PLATEAU MINING COMPANY

RE: NOV 84-4-1-1

PERMANENT ABATEMENT  
PLAN

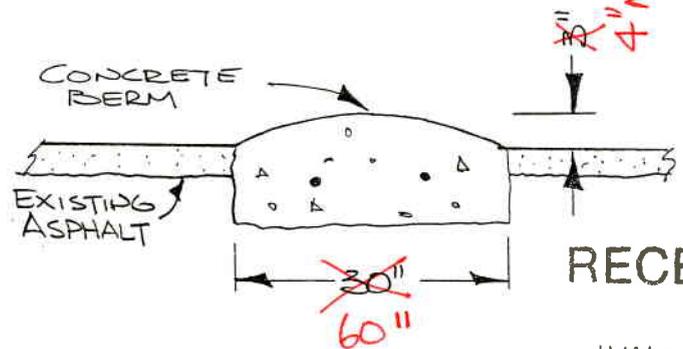
The plan, as submitted, to construct a permanent berm, inlet box and culvert had to be modified. During the time the temporary berm was in place, numerous vehicles were damaged because of the abrupt angle the berm was on in relation to the traffic pattern.

To solve the problem, we put the permanent berm on more of an angle to ease the impact on vehicles. In doing this, it eliminated the need for the inlet box and culvert; the attached plan shows the modification. Runoff will flow along the berm and in a lined ditch to the existing inlet box, accomplishing the goal.

~~NEW CONCRETE BERM  
SEE DETAIL A~~

~~NEW INLET BOX~~

~~NEW 12" CMP DRAIN  
PIPE  
CONNECT TO EXISTING  
DOWNSPOUT~~
